Addendum 1

ITB-12-06

CITY OF WINTER HAVEN
 REPLACEMENT OF LIFT STATION 110

LS-110
 LIFT STATION DETAILS

SHEET NO. 5

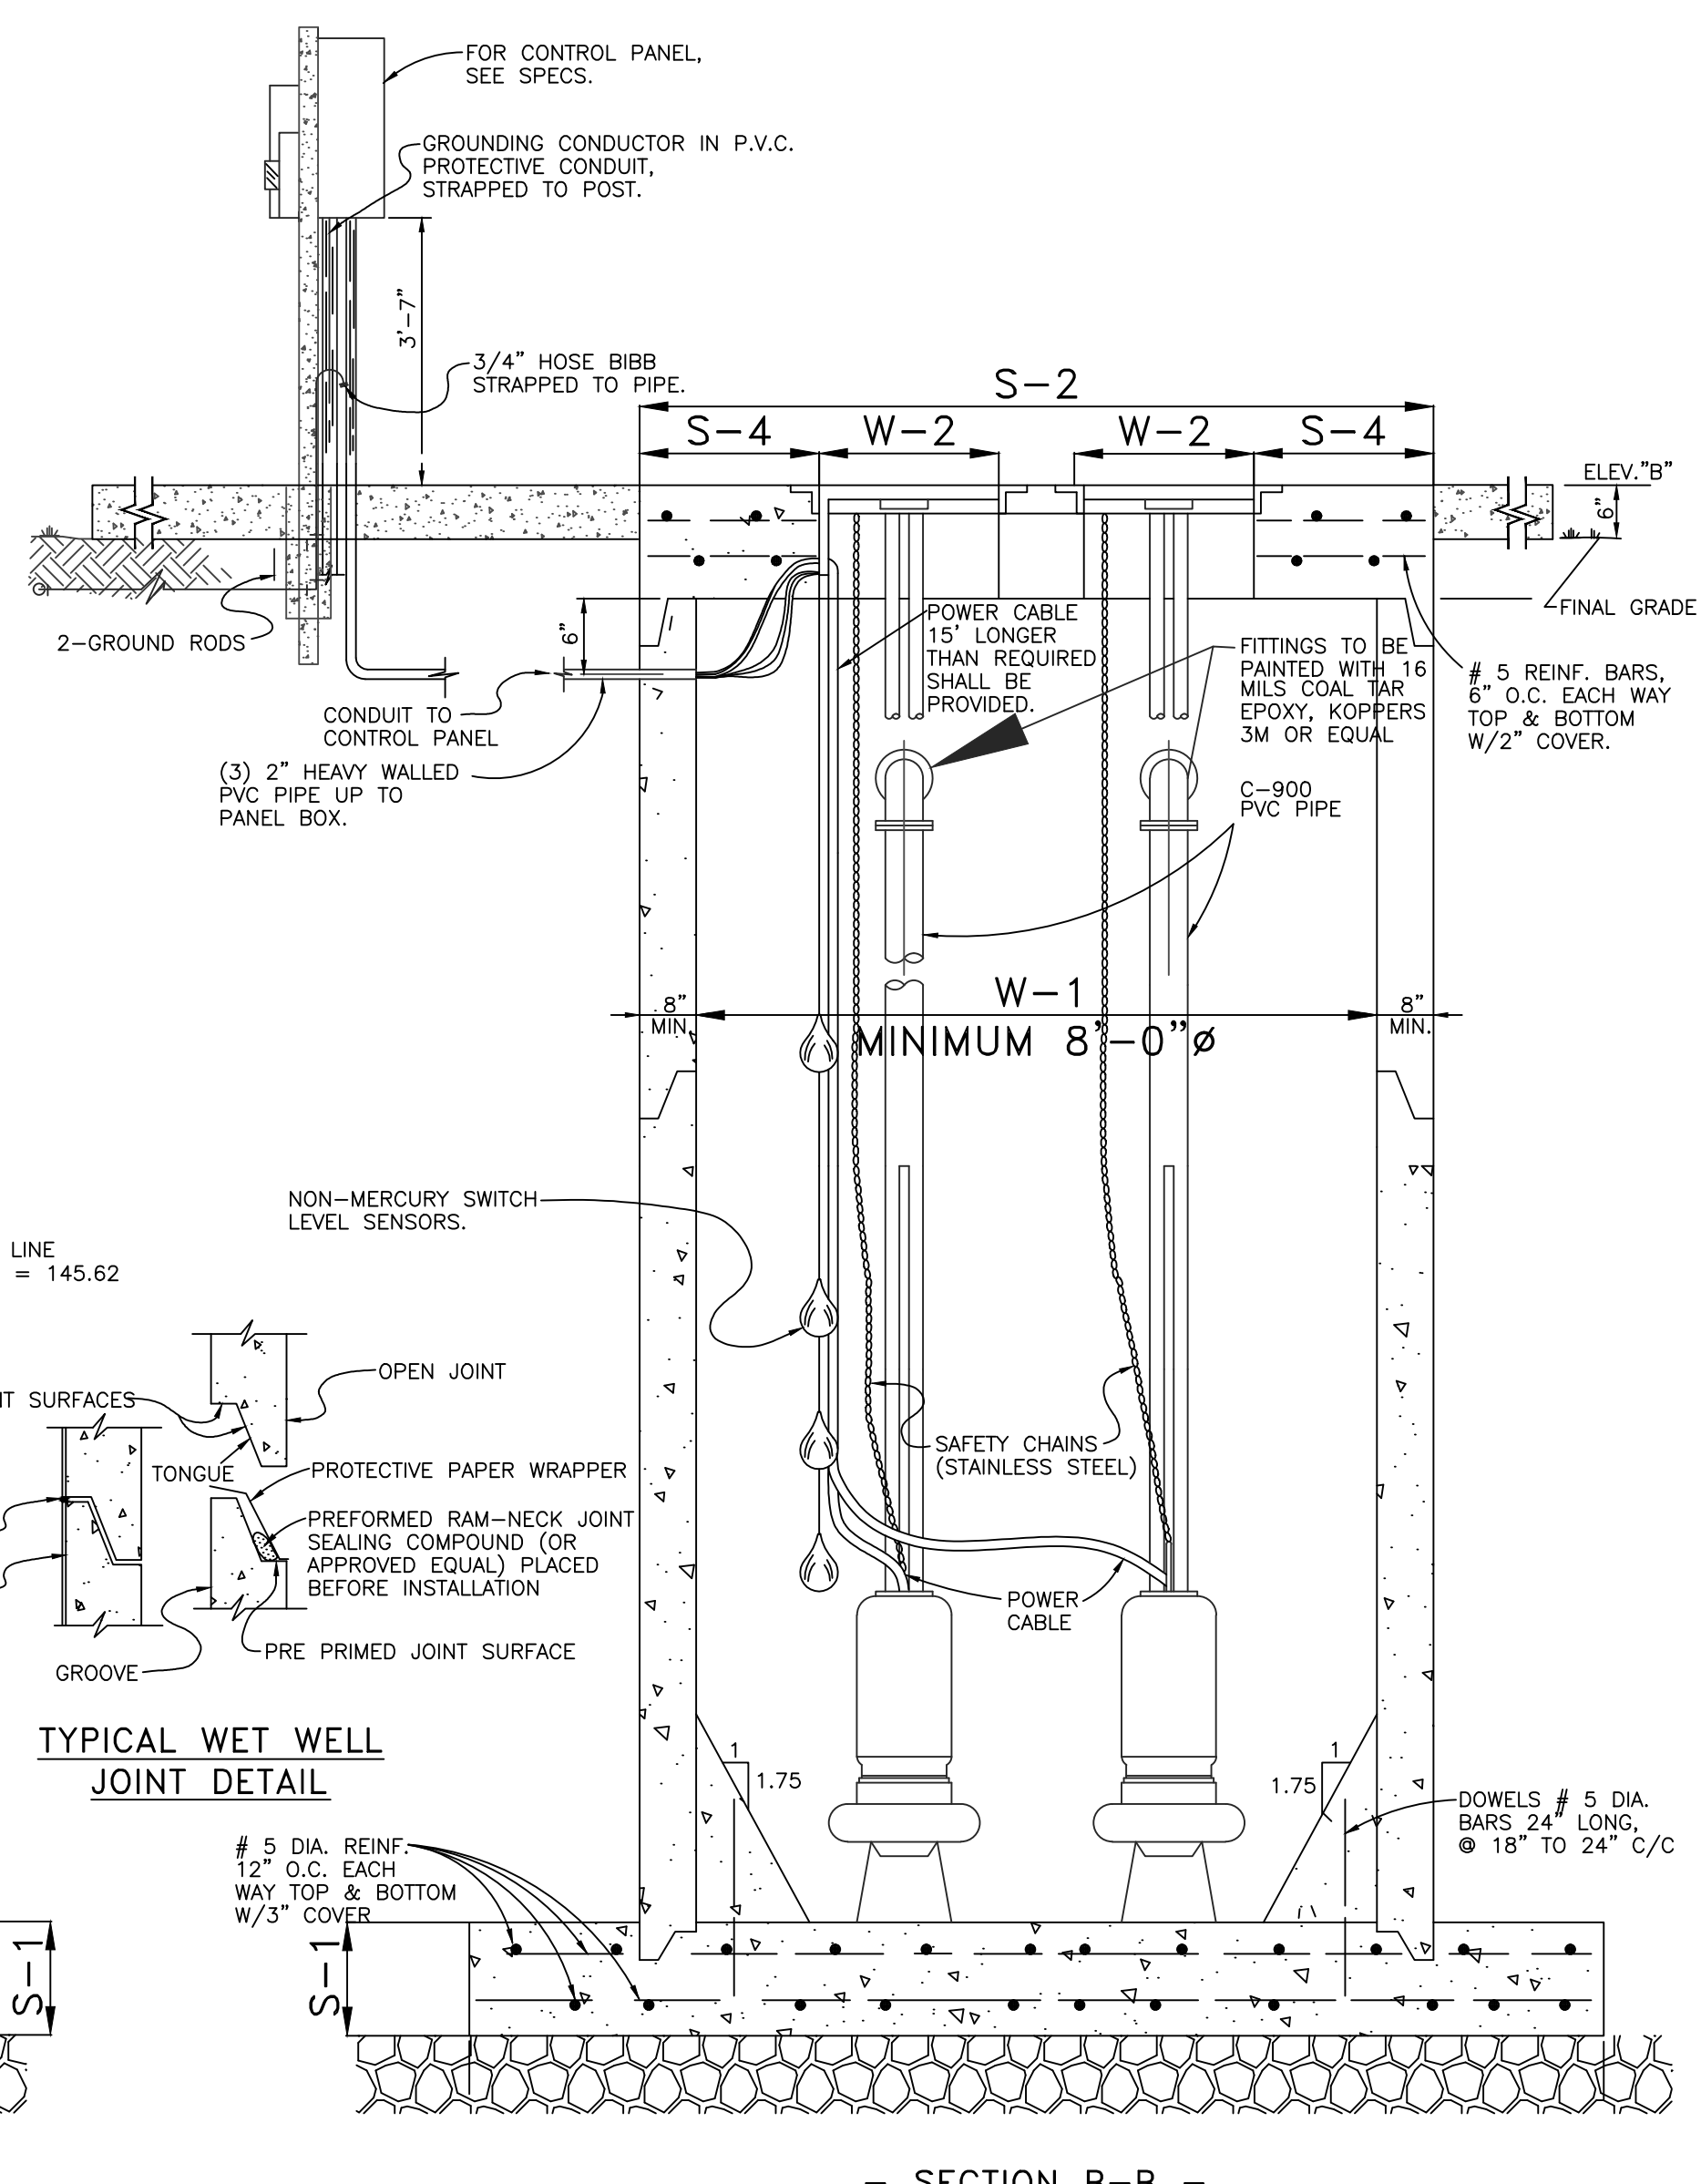
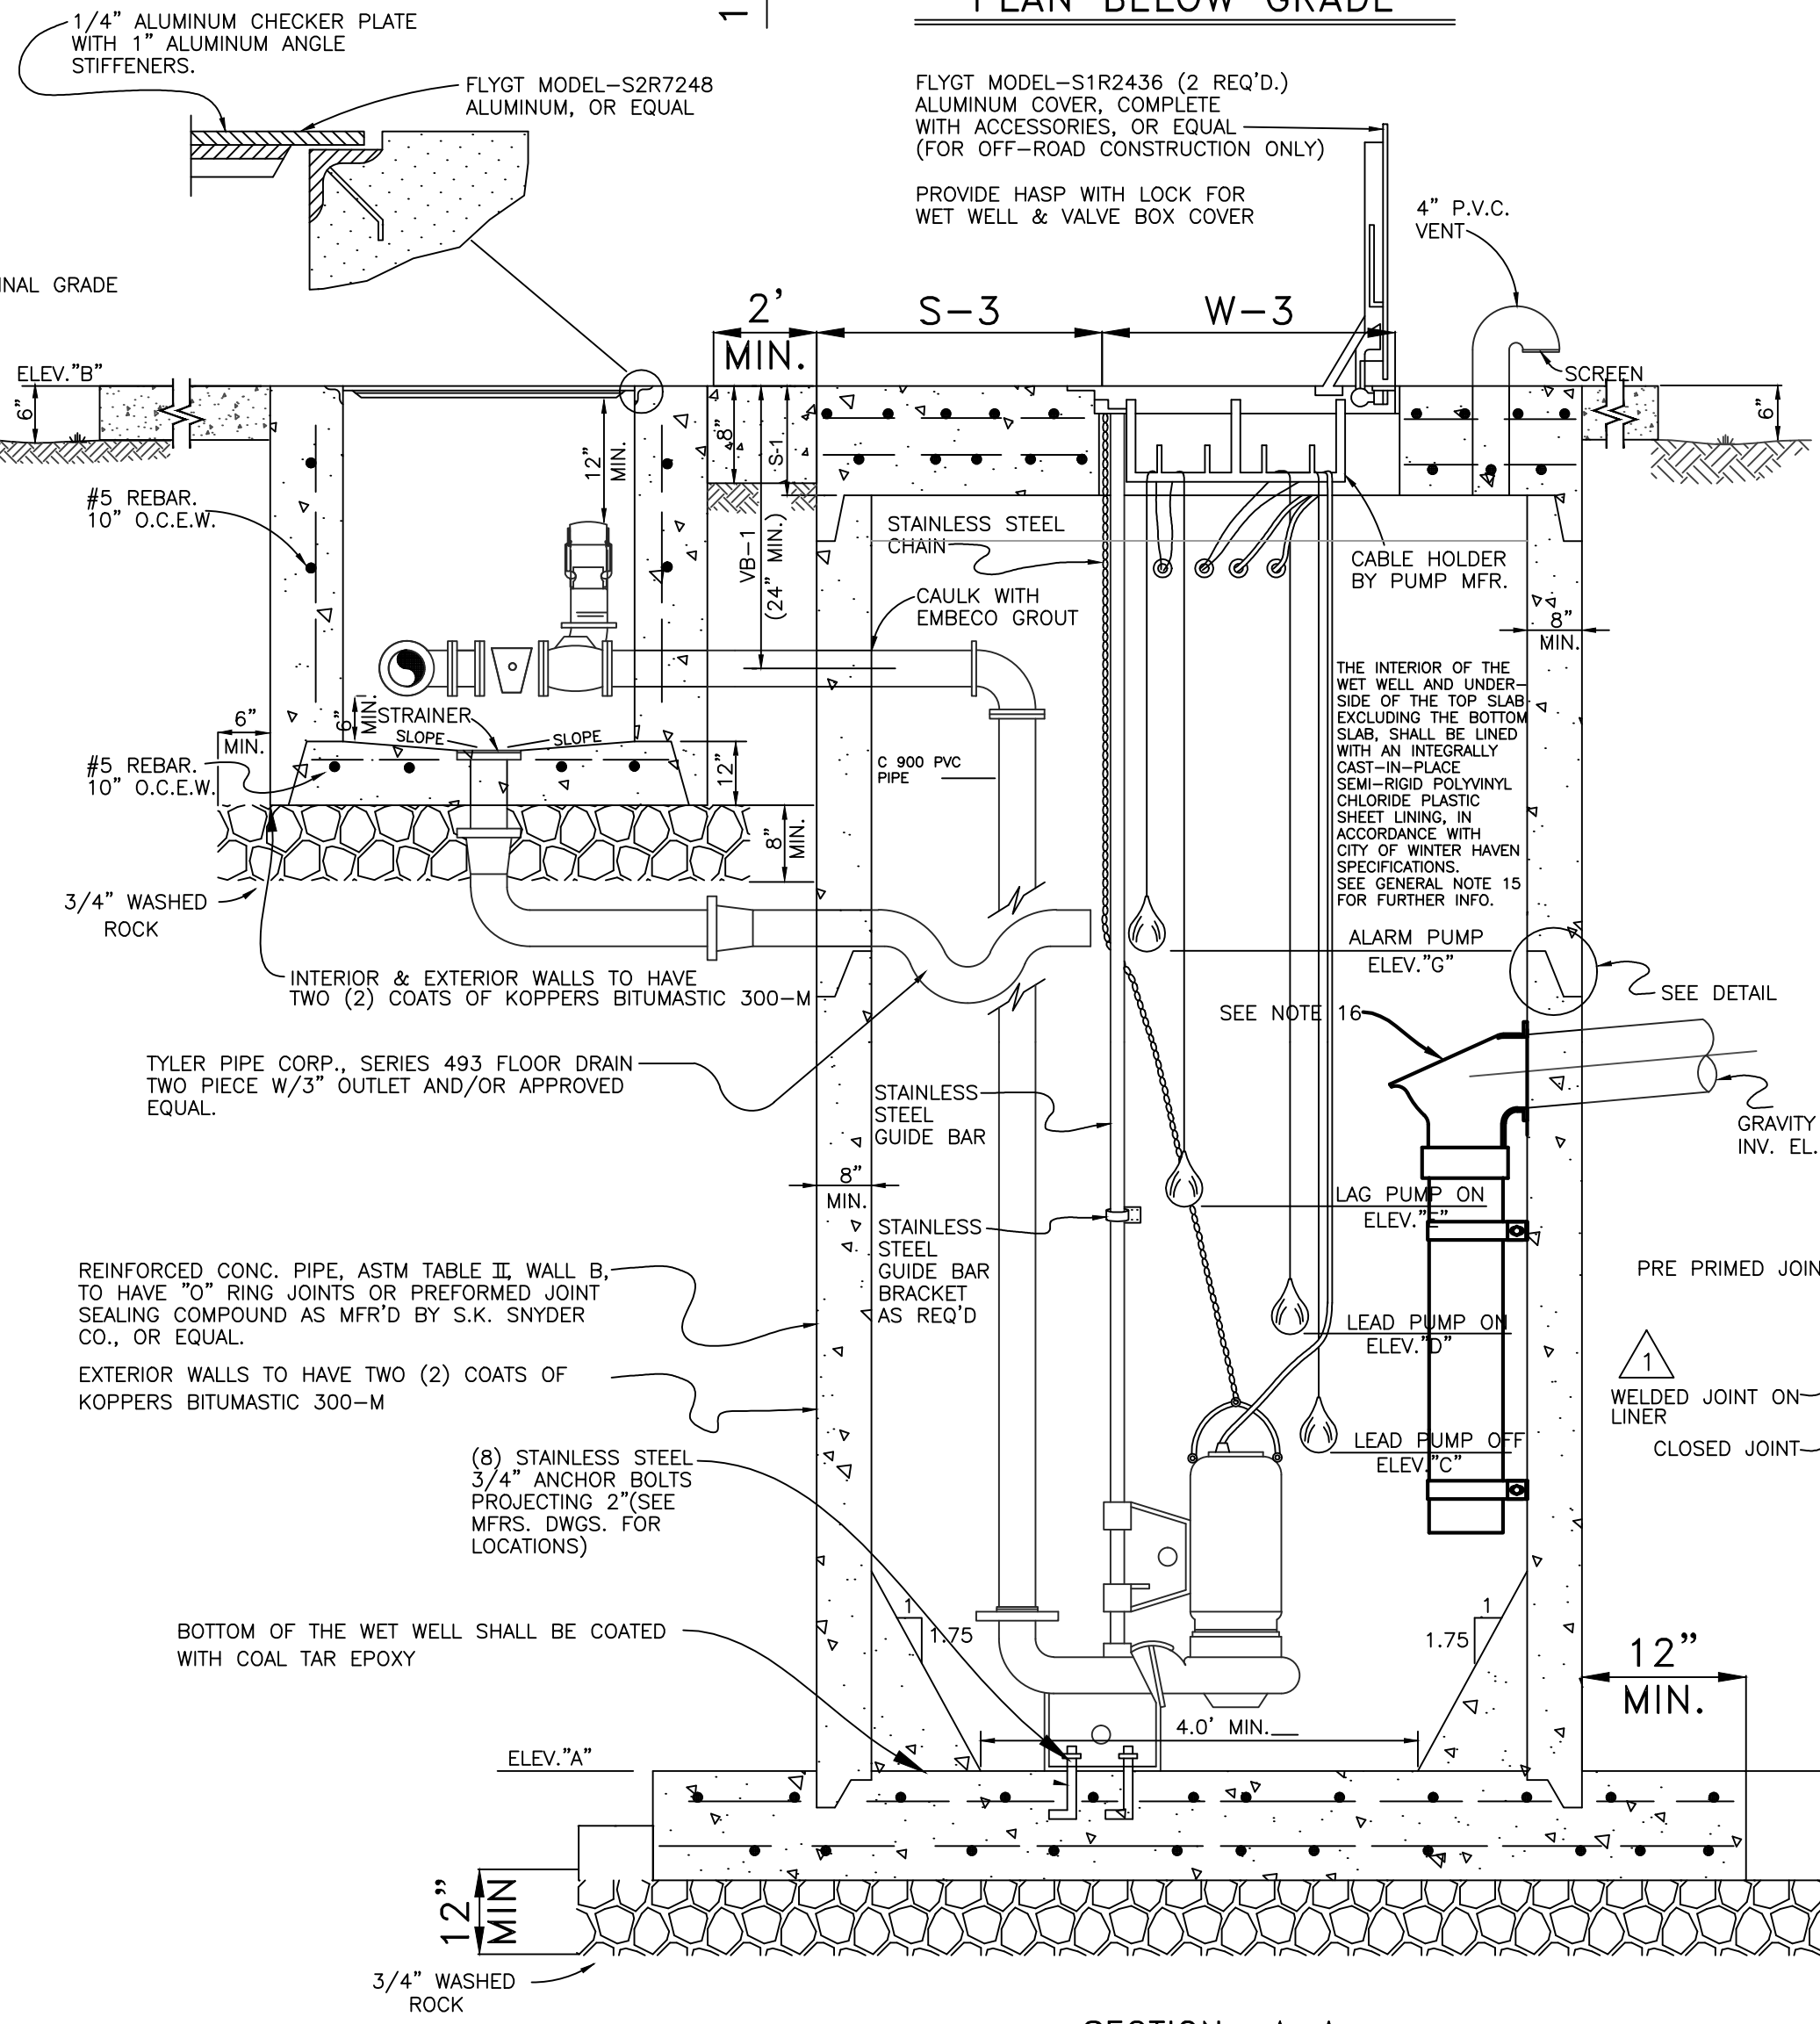
1. **Surge Arrestor/Protector:** The City does not supply the surge arrestor; it shall be furnished by the Contractor. The plans (Sheet 5) and the Specifications (Section 6.9.9.4) have been revised to show and specify a Square “D” type surge protector or approved equal instead of the Volt Guard Type VGX that was previously specified. The surge protector shall be connected to the load side of the main service breaker and located externally on the main disconnect box. Refer to the accompanying revised Sheet 5 of the plan set and page number 6-20 of the Specifications.

A Square "D" type surge protector or approved equal shall be included and wired to protect motors and control equipment from induced line surges. The surge protector shall be connected to the load side of the main service breaker and located externally on the main disconnect box. Revised 11/08/2011
